DESCRIPTIVE REPORT

General Locality Providence River

Sublocality Pomham Rocks to Fox Point

H-10772

AWOIS 9941

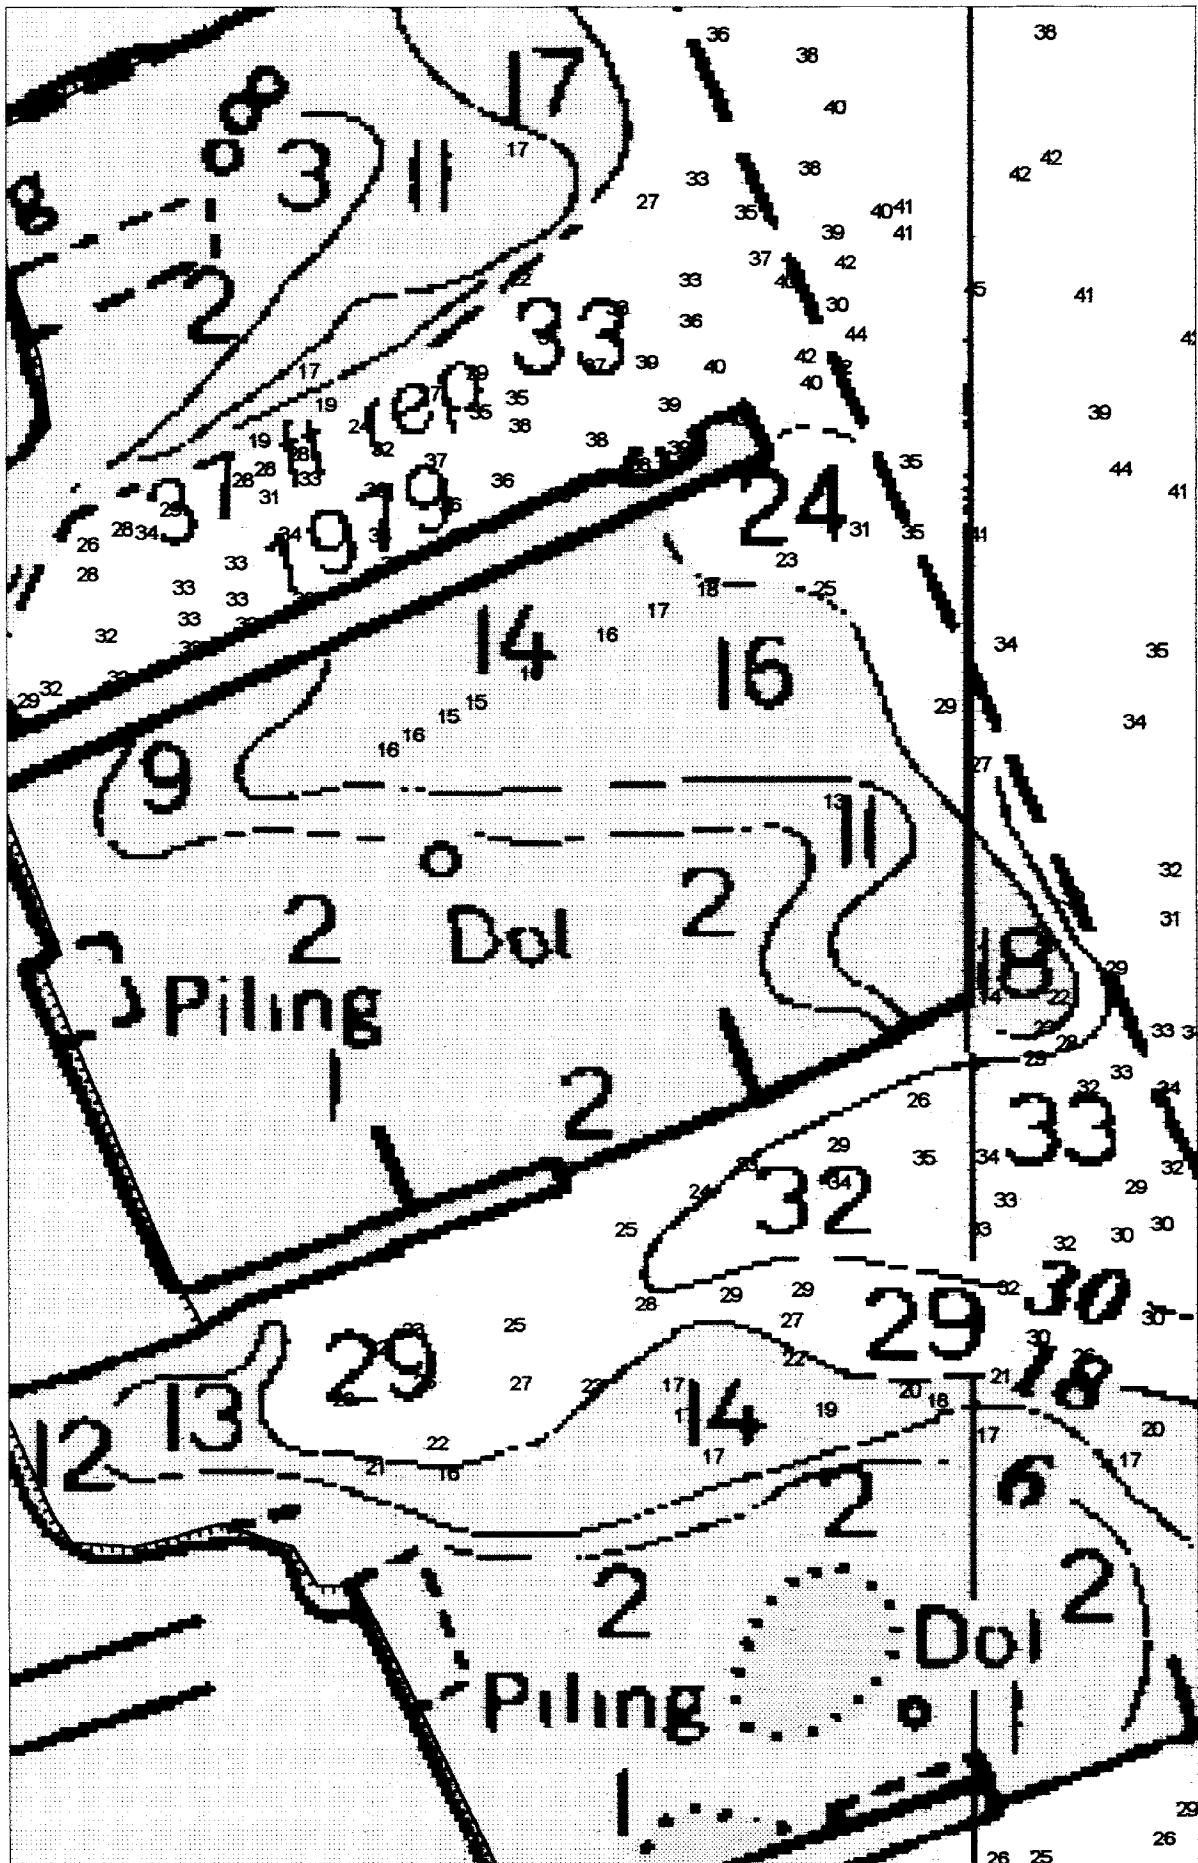
Investigation Summary: Two-hundred percent side scan sonar coverage as well as single beam hydrography at 10-meter line spacing was conducted over the area of this item. Depths along the south side of the the pier ranged from 40 ft (12.2m) at the offshore end and gradually sloping to 29 22 ft (9.8m) at the inshore end. Depths on the north side were from 24 ft (7.3m) on the north edge to 31-37 ft (9.4m - 11.3m) in the center of the slip. A page sized plot of the soundings taken during this investigation is included in the appendices of this report.

The hydrographer recommends removing the "37 ft rep 1979" note from the chart and charting current survey soundings in the area. *Concur*

AWOIS 9942

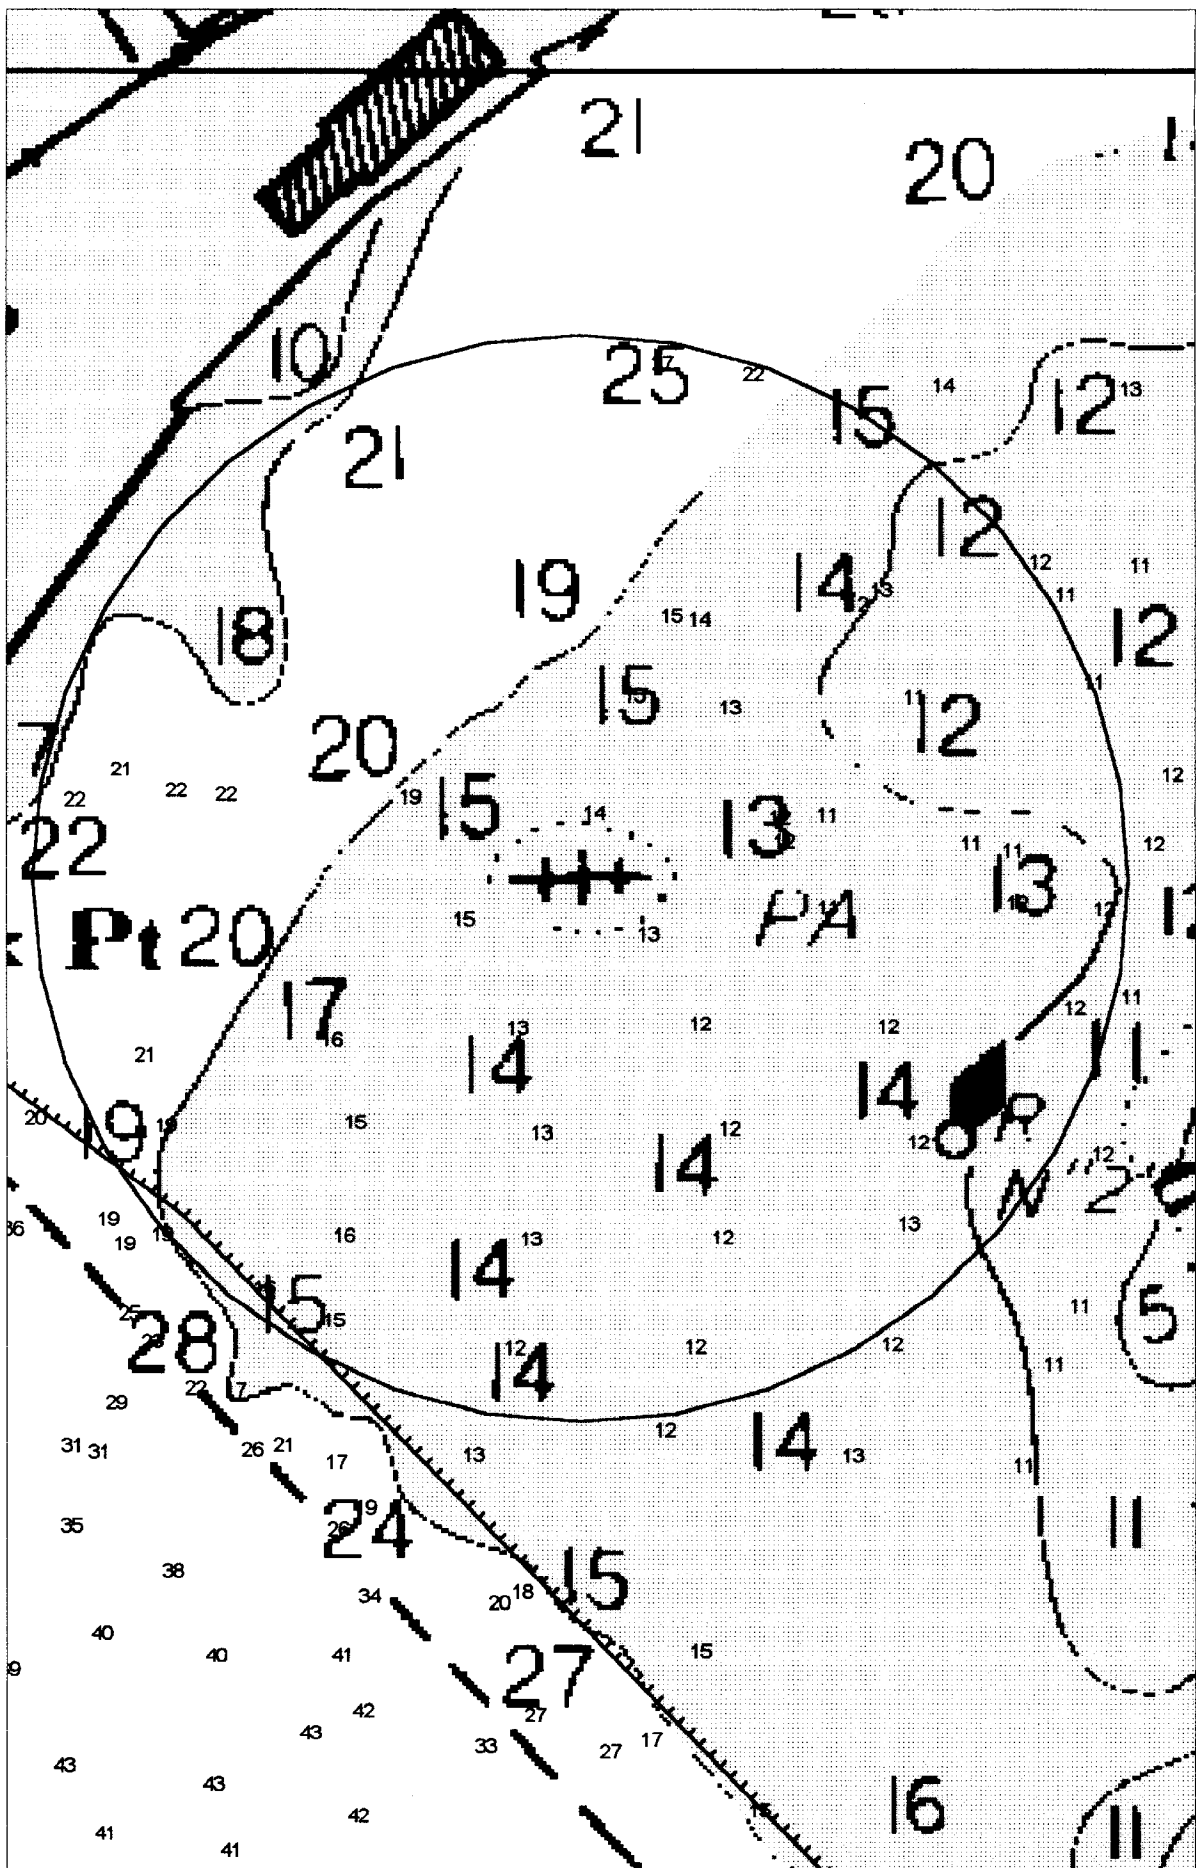
Investigation Summary: A 150-meter radius 200% side scan sonar coverage investigation was conducted and nothing was found.

The hydrographer recommends removing the submerged wreck PA from the chart. *DO NOT REMOVE*

150 METER RADIUS SSS COVERAGE IS INCOMPLETE. RETAIN AS CHARTED

AWOIS 9943

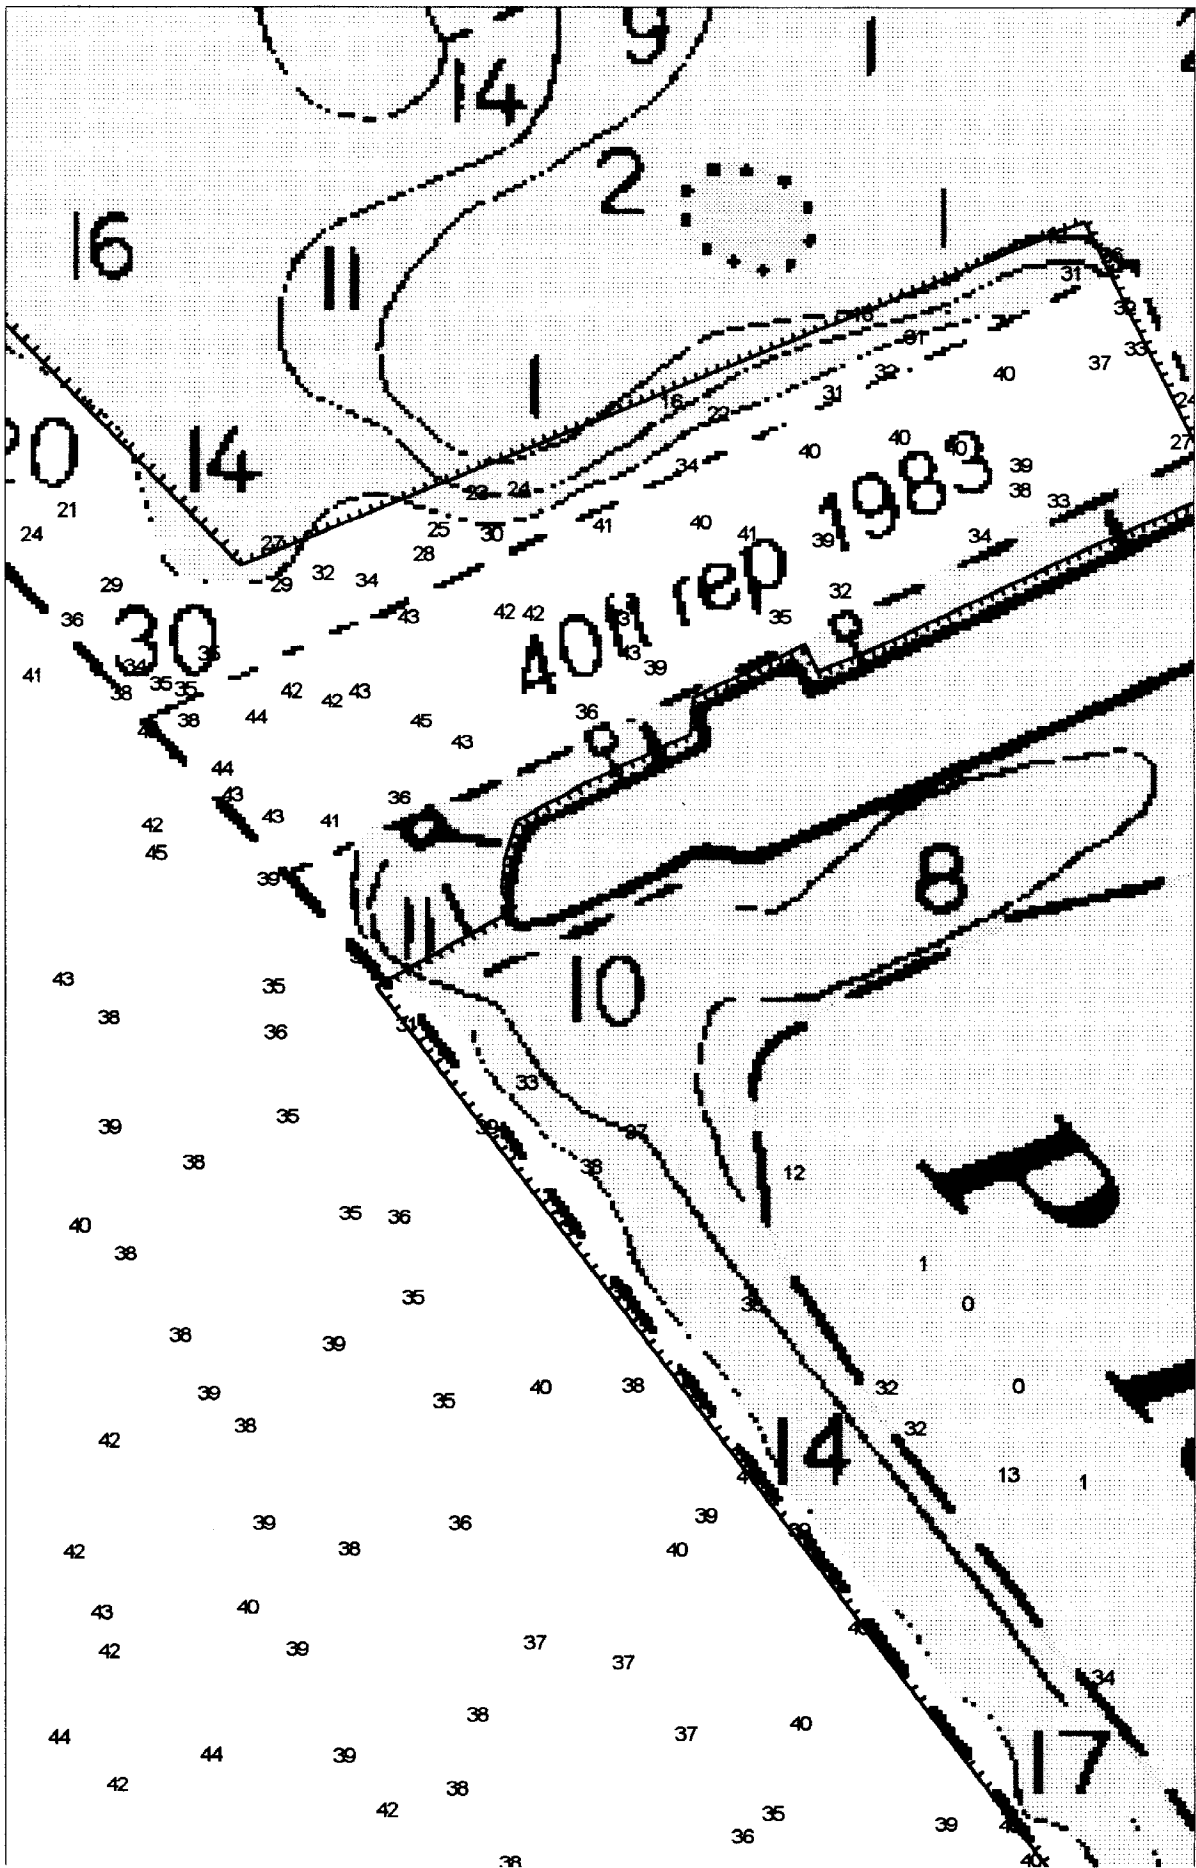
Investigation Summary: Two-hundred percent side scan sonar coverage as well as single beam hydrography at 10-meter line spacing was conducted over the area of this item. Depths in the area range from 32-36 ft (9.6m - 11.0m) alongside the pier to 39-45 ft (11.9m - 13.7m) in the center of the slip to 38-40 ft (11.6m - 12.2m) on the north side of the slip.

The hydrographer recommends removing the "40 ft rep 1983" note from the chart and charting current survey soundings in the area. *Concur.*

AWOIS 9944

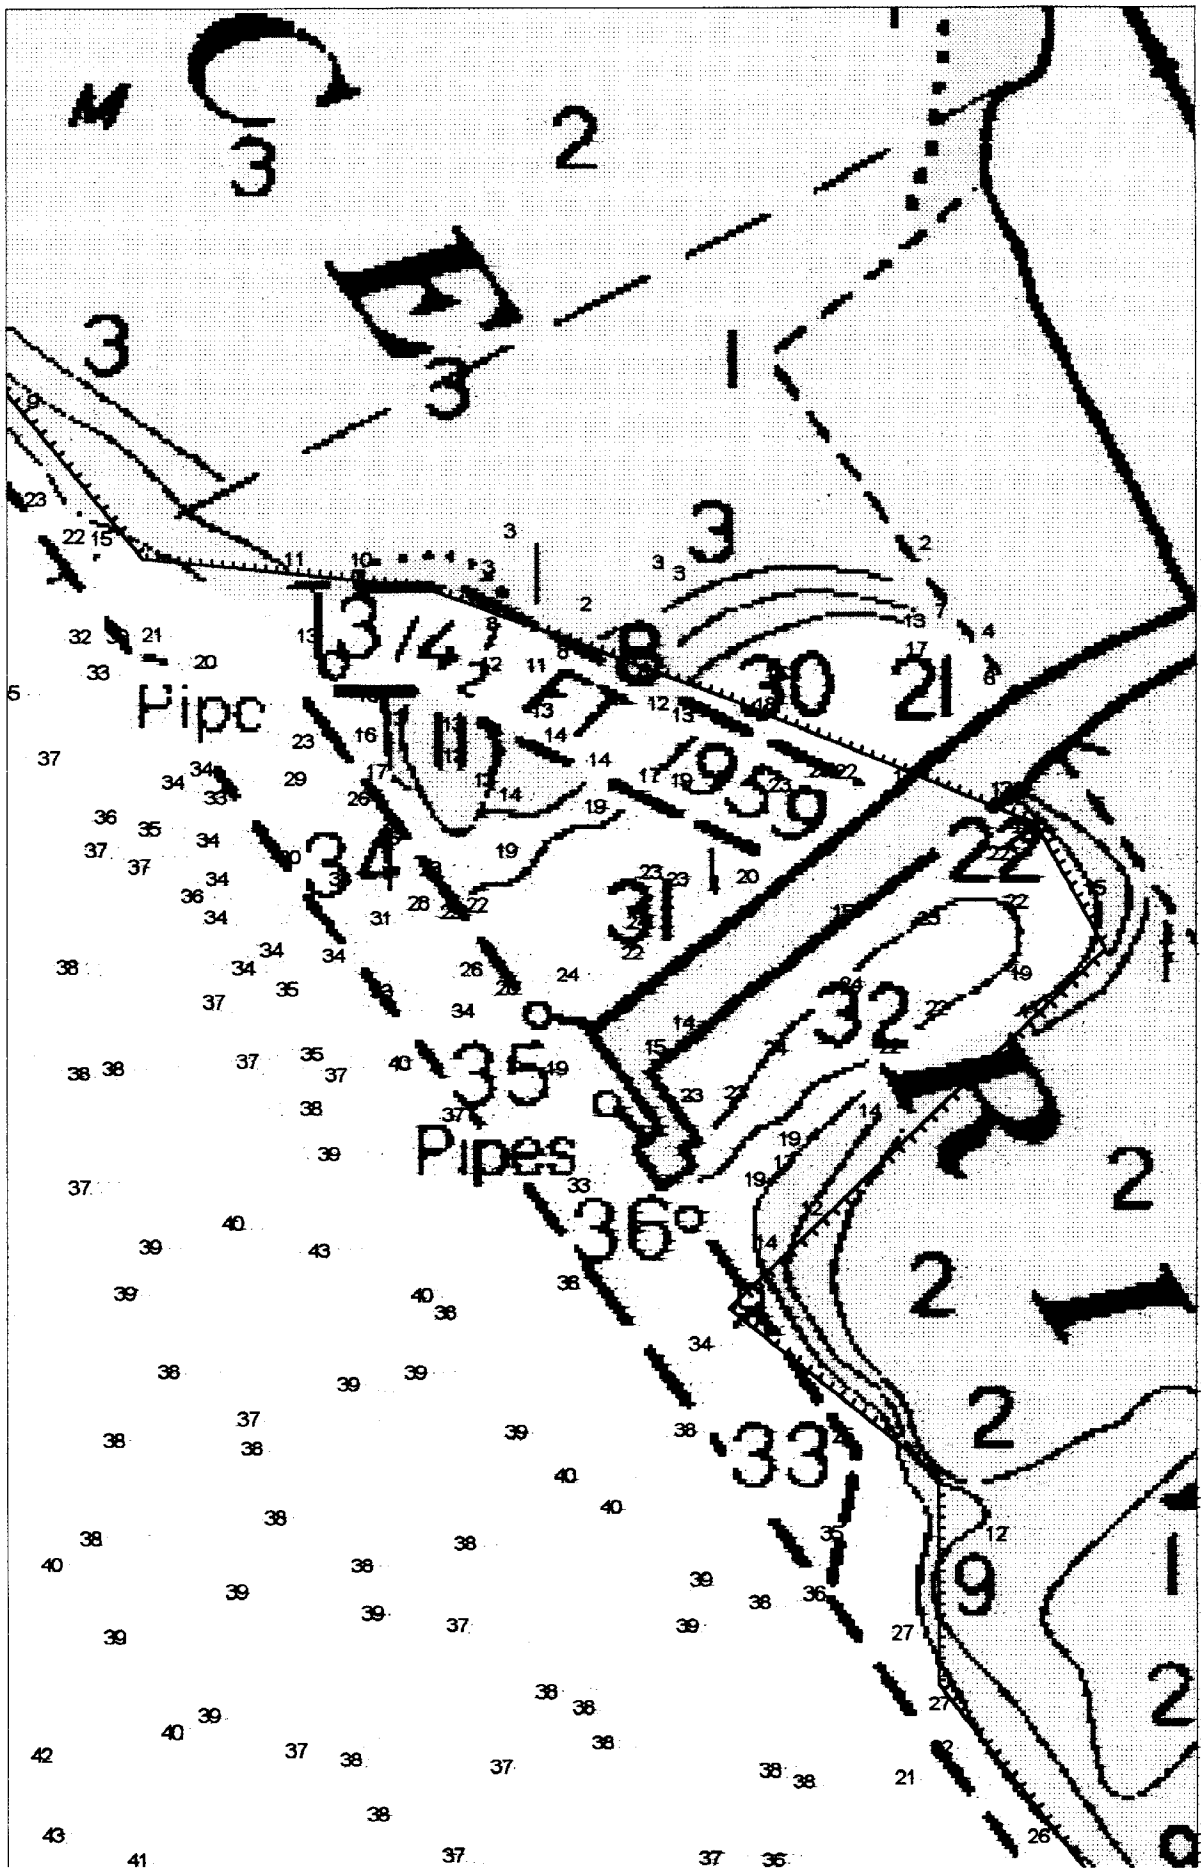
Investigation Summary: An echo sounder investigation was conducted at 10-meter line spacing across the area of the charted dredged channel. No evidence of the channel was found. The adjacent fuel pier is now in ruins. A page sized plot of this development is included in the appendices to this report.

The hydrographer recommends removing the "14½ FT 1959" note and dashed channel lines from the chart and charting current survey soundings in the area. *CONVD, UNLESS OTHER INFORMATION INDICATES OTHERWISE. PRESENT SURVEY DEPTHS IN THE AREA ARE 8 TO 22 FT.*
